## North Westerly - PD 1<sup>st</sup> Review

To: Southern Land Company  
From: Aly Burkhalter, Planner  
Date: April 3, 2024  
Re: PD-001700-2024 North Westerly - PD  
cc: Kelly Driscoll, David Pasic, Jonathan Williams, Miguel Aguilar, Luke Bolinger, Kathy Kron, David Frank

# NORTH WESTERLY PLANNED DEVELOPMENT ZONING MAP AND GUIDE

13  
OF 18

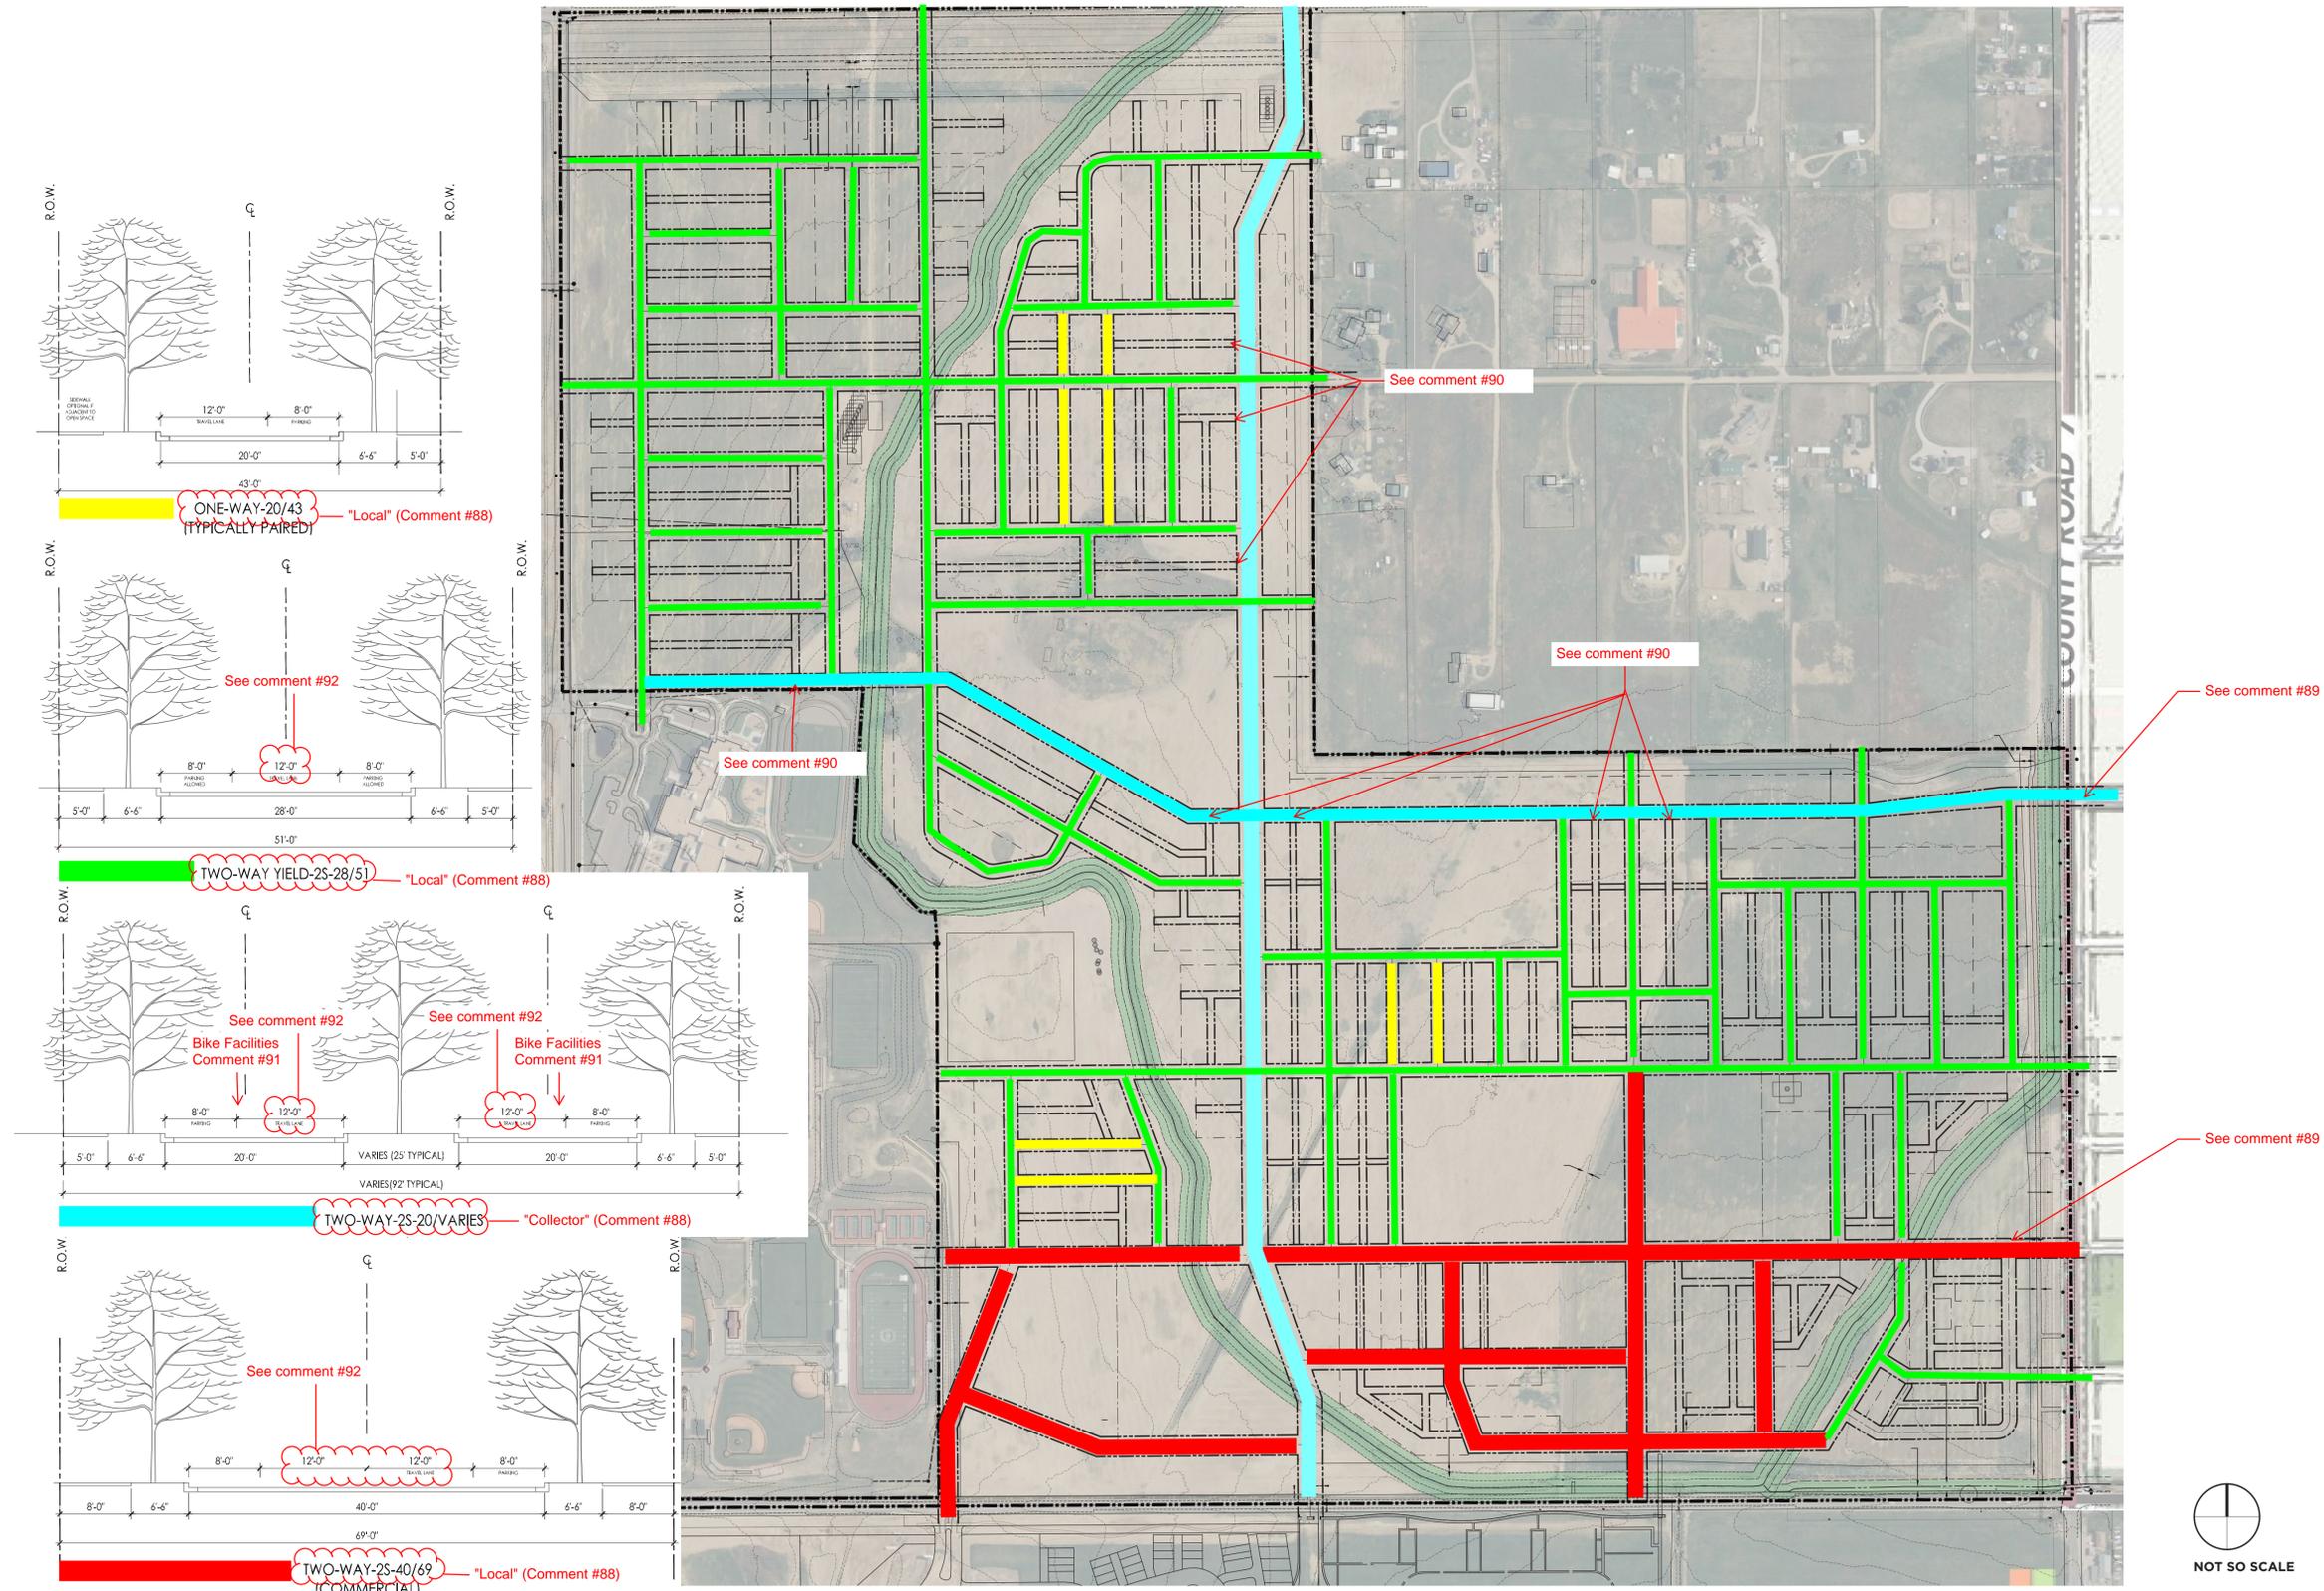
68. Please show mine shaft, as well as are known, on this sheet and all sheets.
69. Staff is concerned about the undermining impacting the developability of the larger multi-family buildings in Phase 1.

- OIL WELL HEAD AS DESCRIBED
- OIL & GAS WELL SETBACK TO LOT LINE (See Comment #71)
- OIL & GAS WELL SETBACK TO BUILDING
- APPROXIMATE LIMITS OF ABANDONED CLAYTON COAL MINE (PER FIGURE 2, PRELIMINARY MINE SUBSIDENCE INVESTIGATION, PREPARE BY WESTERN ENVIRONMENT AND ECOLOGY, INC. DATED DECEMBER 19, 2022).

Staff is concerned about the undermining impacting the developability of the larger multi-family buildings in Phase 1. (Comment #69)

## PHASING PLAN

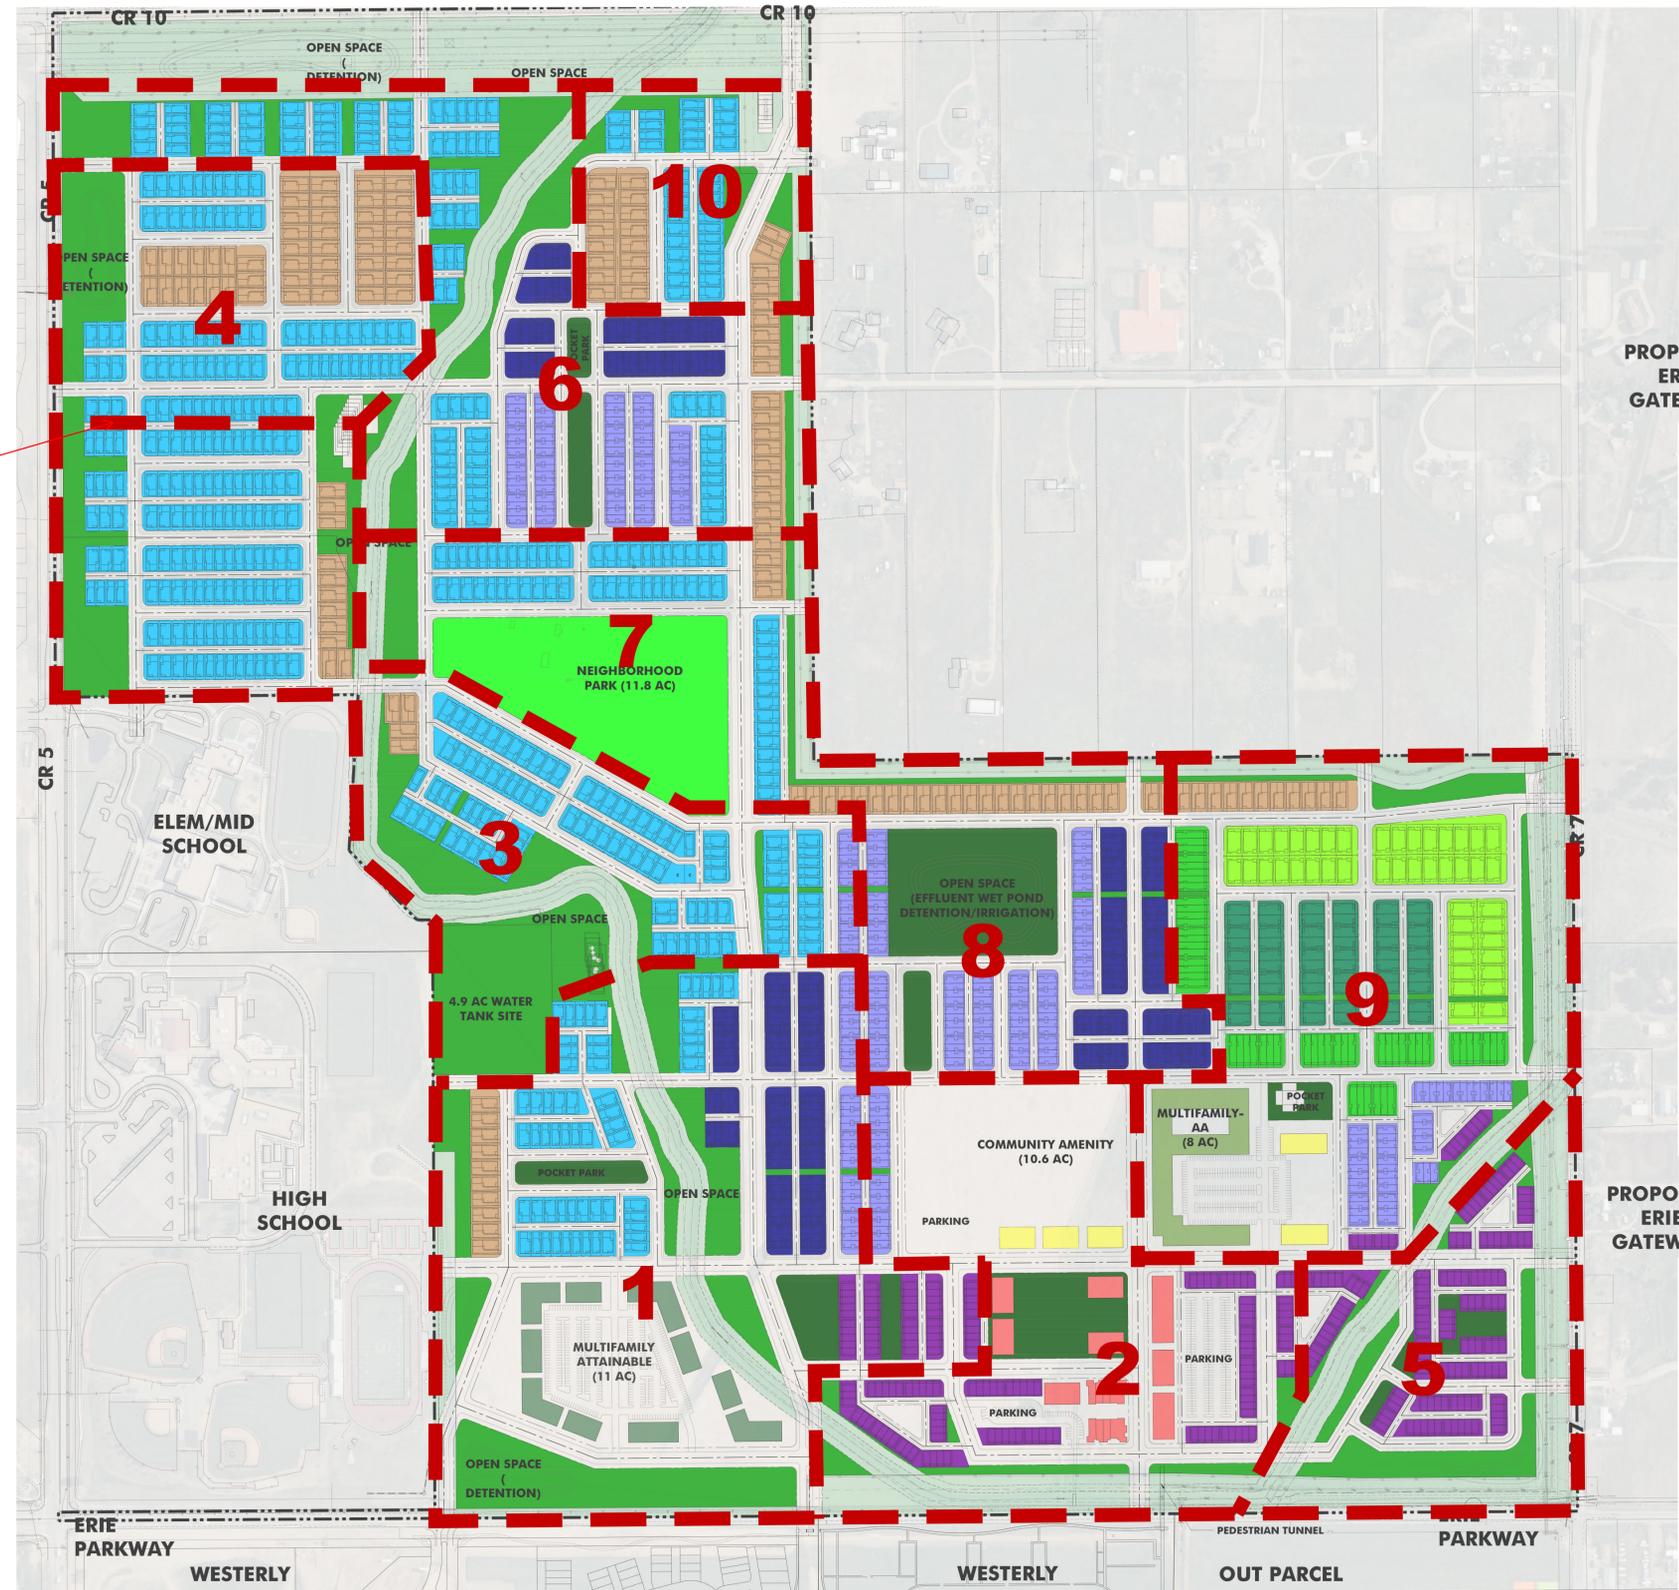
93. Please show phasing boundaries to edge of right-of-way, lot, or tract rather than centerline of right-of-way or through tracts. A thinner boundary line may be required.
94. Please provide a land summary chart per phase showing number of dwelling units by type and parks and open space by type per phase.

16. Sheet 17, Phasing Plan, indicates that some areas are planned to be constructed before construction of the receiving detention pond. Note that detention ponds must be constructed prior to development within the basin that will increase flow conditions.

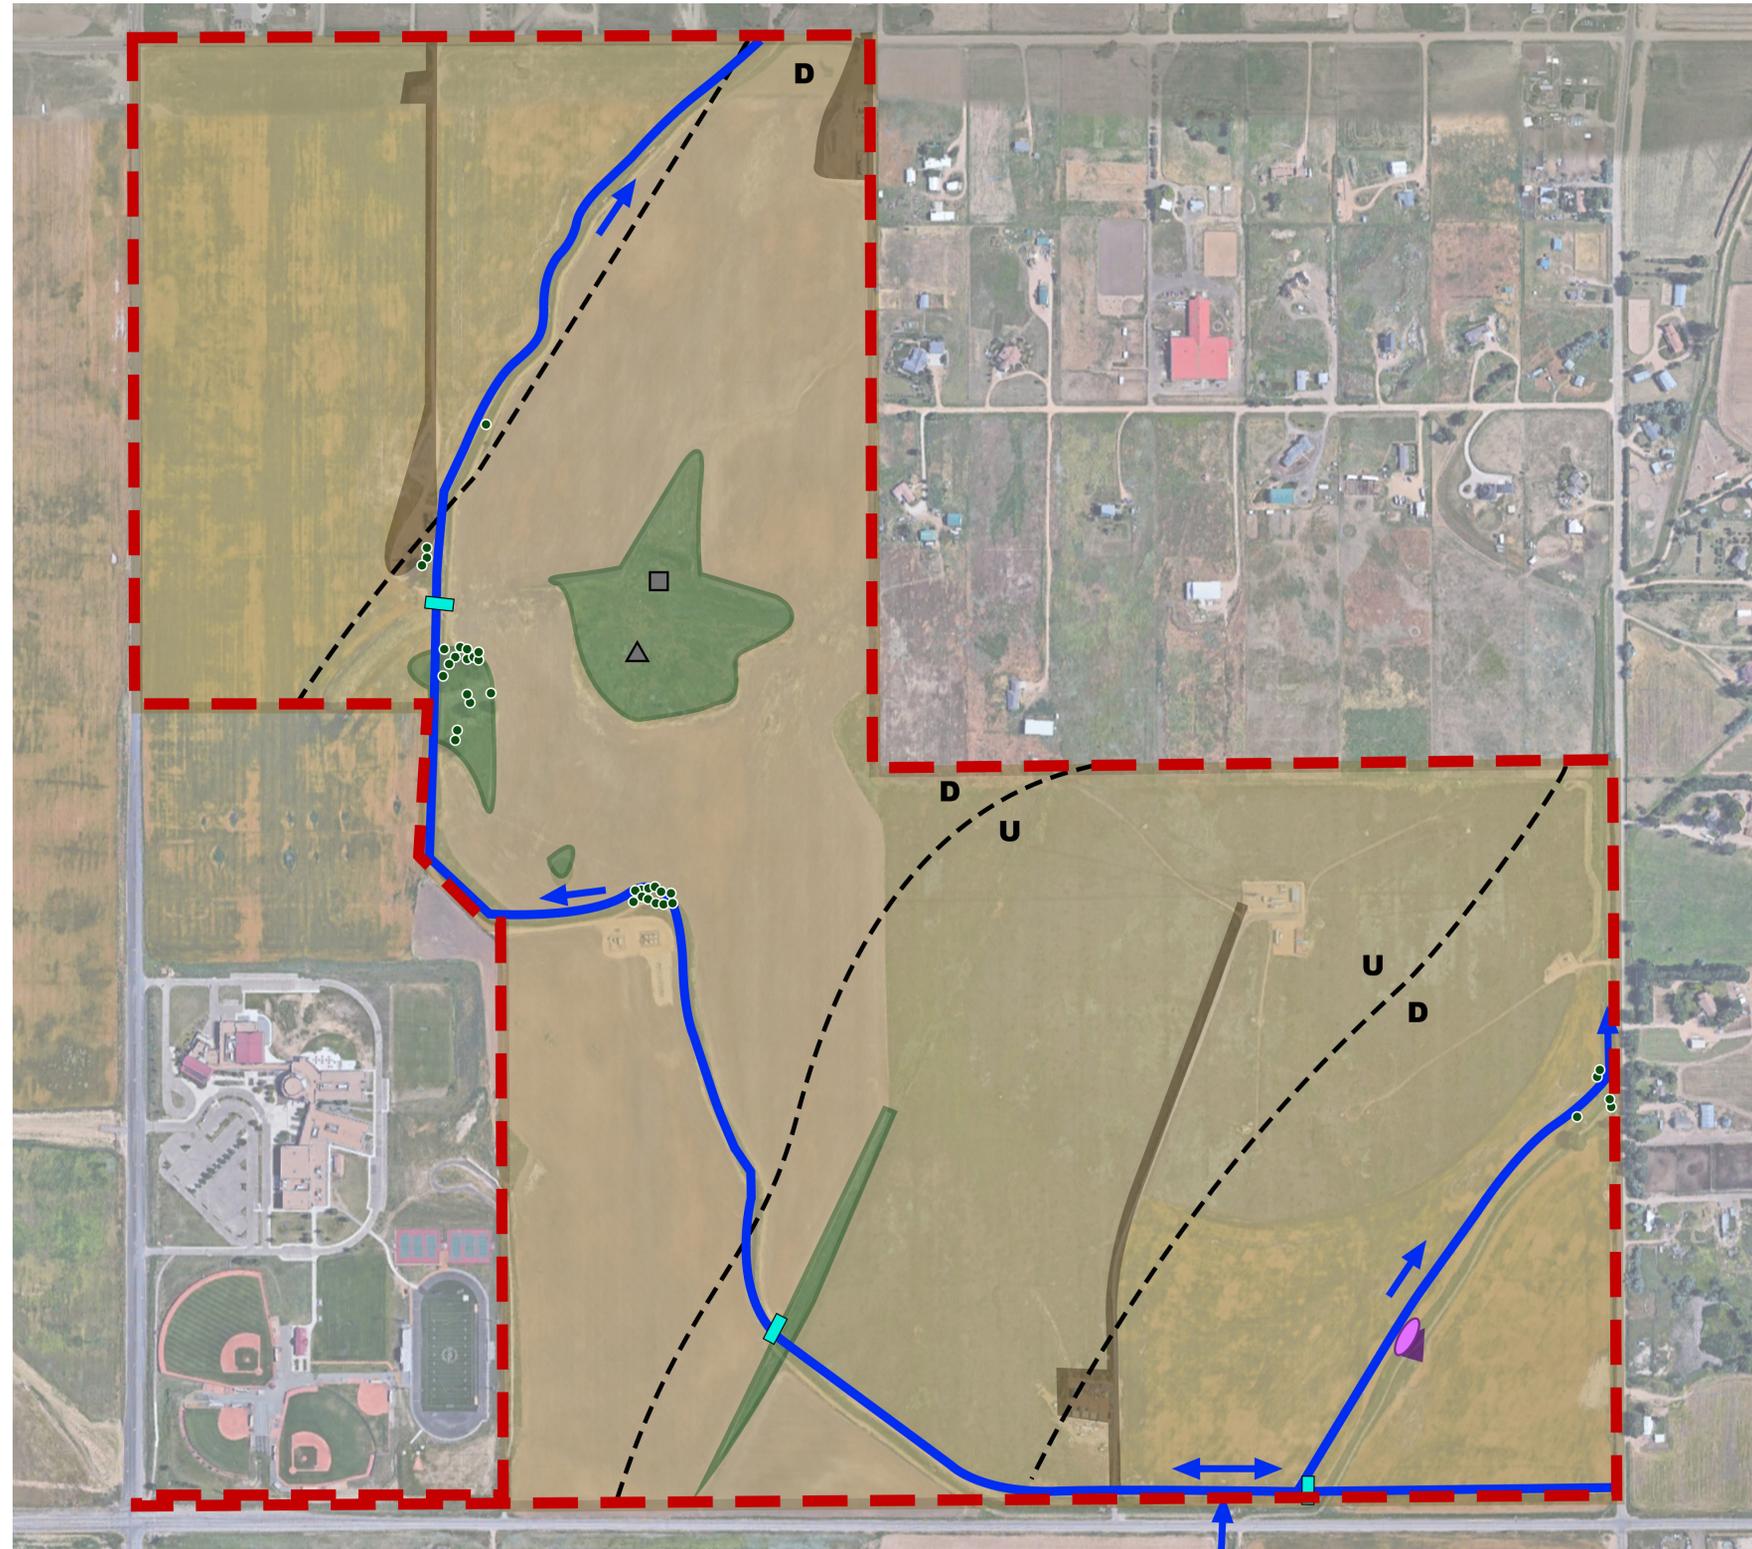
5. The text of the report states that no wetlands are located within the site; however, Sheet 18, Environmental Plan in the Zoning Map and Guide shows "Palustrine Scrub-Shrub Wetland." Discuss impacts to these wetlands and what mitigation is required.

**Sheet 16 - Parks – Open Space and Landscape Character:**

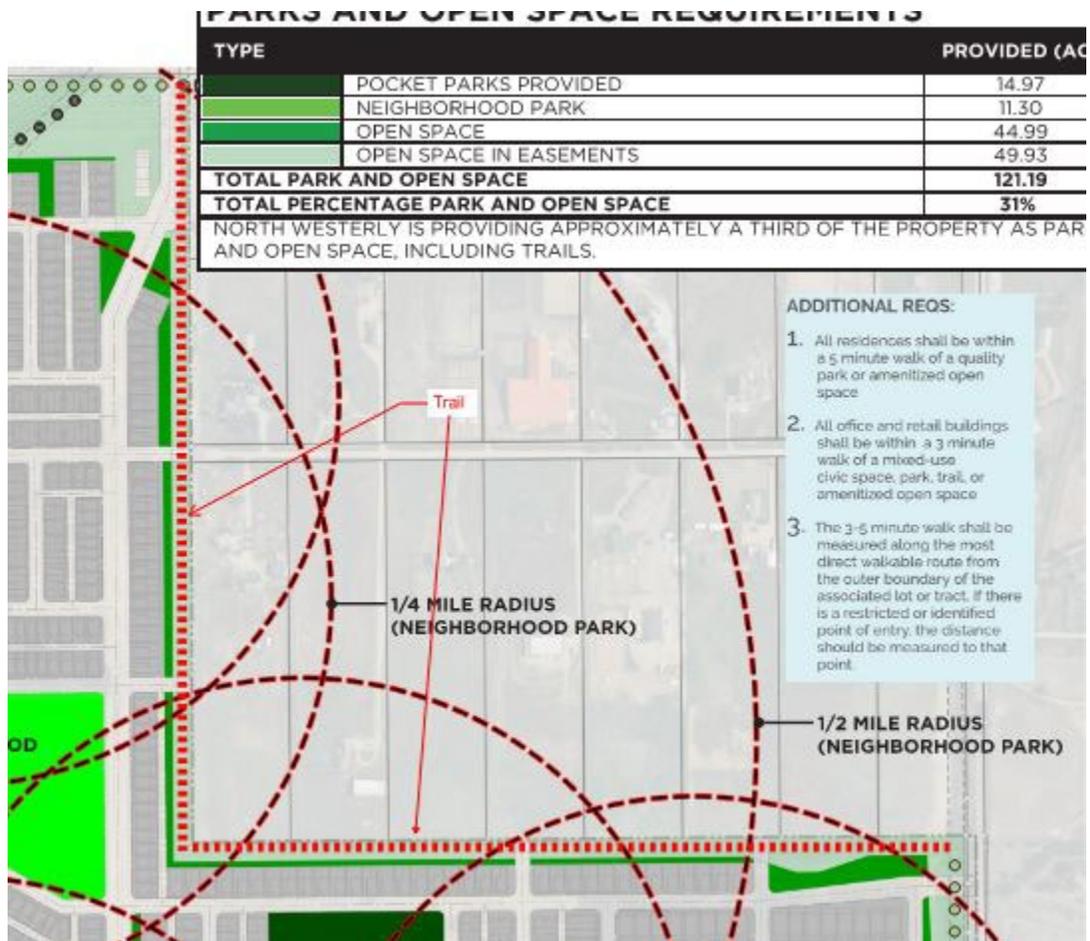
1. Separate landscape character and private landscape standards from parks, open space & trails.
2. The Park and Open Space Requirements Chart should include:
  - a. Anticipated population density utilizing Town of Erie annual persons per dwelling unit (PPDU) estimates.
  - b. Park and Open Space requirements based on density.
  - c. How the development intends to meet the requirements based on guidance from the Mixed-Use Development Parks and Open Space Vision Guide.
  - d. Utilize Park and Open Space typologies from the Mixed-Use Development Guide.
3. ¼ mile radii shown on map is not relevant. See page 36 of the Mixed-Use Development Guide

for how to apply spatial requirements to parks, trails and open space areas.
